STAFF RECOMMENDATION
2129 Belmont Boulevard
June 19, 2019

Application: New Construction- Addition
District: Belmont-Hillsboro Neighborhood Conservation Zoning Overlay
Council District: 18
Base Zoning: R8
Map and Parcel Number: 10416009600
Applicant: Matt McCrary, Allard-Ward Architects
Project Lead: Jenny Warren, jenny.warren@nashville.gov

<p>Description of Project: Application is a revision to a previously approved rear addition.</p> <p>Recommendation Summary: Staff recommends approval of the proposed addition with the following conditions:</p> <ol style="list-style-type: none">1. Staff approve the final doors and windows prior to purchase and installation; and,2. The HVAC shall be located behind the house or on either side, beyond the mid-point of the house; and3. Staff approve the material of the back porch columns <p>Staff finds that the project meets Section II.B of the <i>Belmont-Hillsboro Neighborhood Conservation District: Handbook and Design Guidelines</i></p>	<p>Attachments A: Site Plan B: Elevations</p>
---	--

Figure 3: Ashwood Avenue elevation

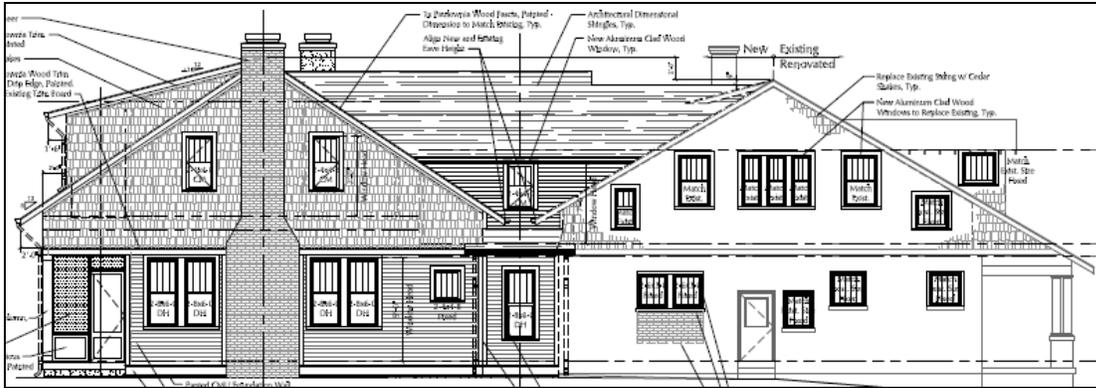
Height & Scale: The addition will use a side gabled roof form, like the historic house. The new ridge will sit about forty-four feet (44') beyond the historic ridge and the height of the new ridge line will be about two feet (2') taller than the historic ridge, at about twenty-six feet, six inches (26'6") tall. A section of rear gabled roof will connect the two ridges and will sit six inches (6") below the historic ridge line, as per the guidelines. This section will step up one foot (1') approximately forty-feet (40') back from the front of the house, as is allowed by the guidelines. Then the new side gable will be an additional one foot (1') taller (Figures 3 & 4).

Staff finds that the project meets section II.B.1.a and b and II.B.2 for height and scale of an addition.

Figure 4: North elevation. Note the differing eave heights.

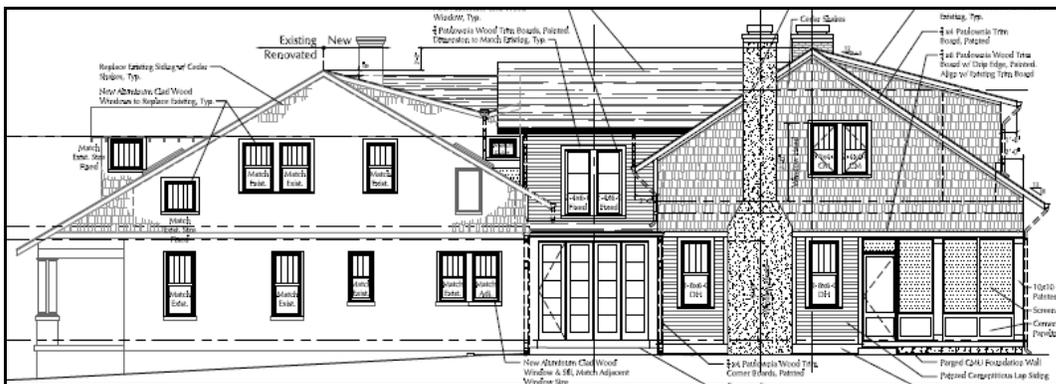
The foundation height and width have not been altered in this revision and are appropriate.

2 North Elevation
Scale: 1/8"=1'-0"

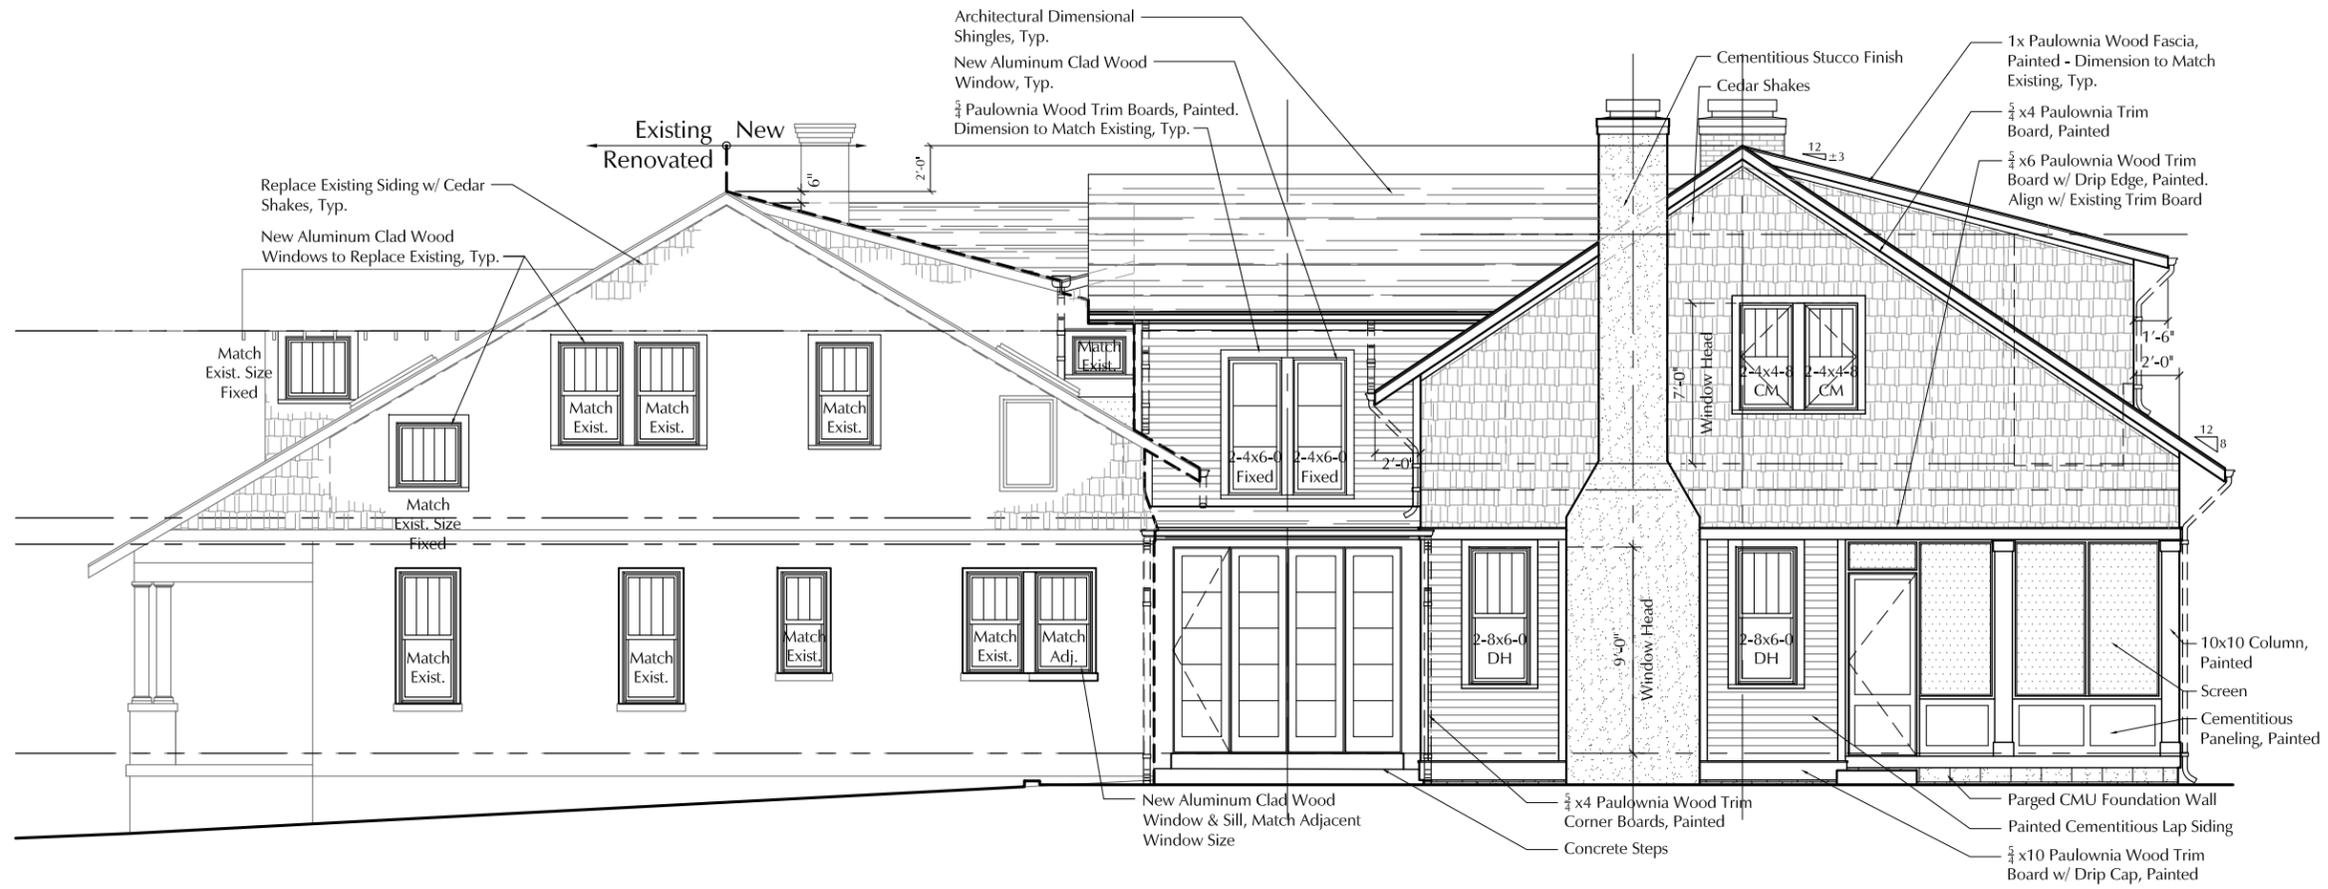
Proportion and Rhythm of Openings: Some windows have been altered since the April application. However, the windows on the revised addition are still all generally twice as tall as they are wide, thereby meeting the historic proportions of openings. There are no large expanses of wall space without a window or door opening. Staff finds the project's proportion and rhythm of openings to meet Section II.B.1.g.

1 Rear Elevation
Scale: 1/8"=1'-0"

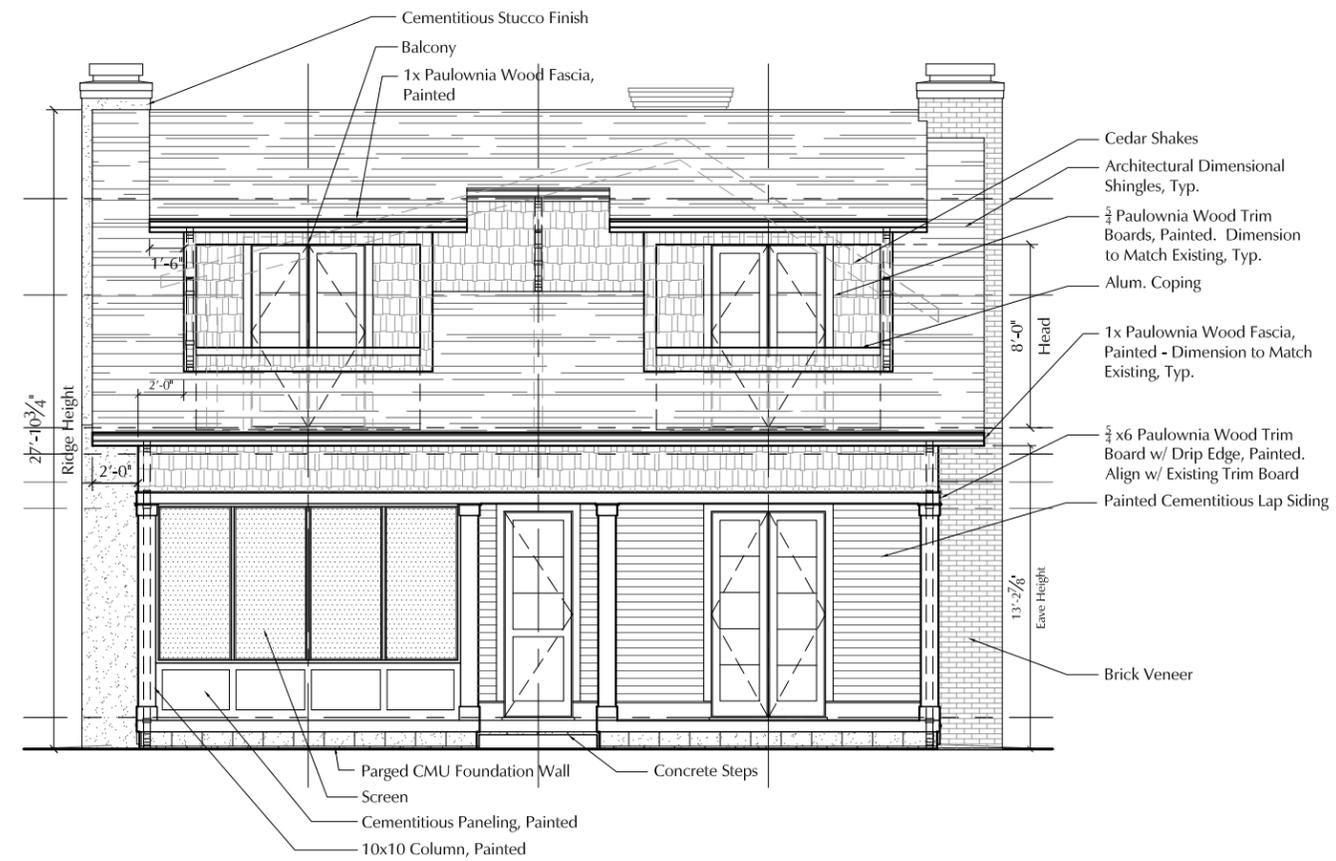
Appurtenances & Utilities: No changes to the site's appurtenances were indicated on the drawings. The location of the HVAC and other utilities was also not noted. Staff asks that the HVAC be located on the rear façade, or on a side façade beyond the midpoint of the house. The project meets section II.B.1.h.

1. Staff approve the final doors and windows prior to purchase and installation; and,
2. The HVAC shall be located behind the house or on either side, beyond the mid-point of the house; and
3. Staff approve the material of the back porch columns.
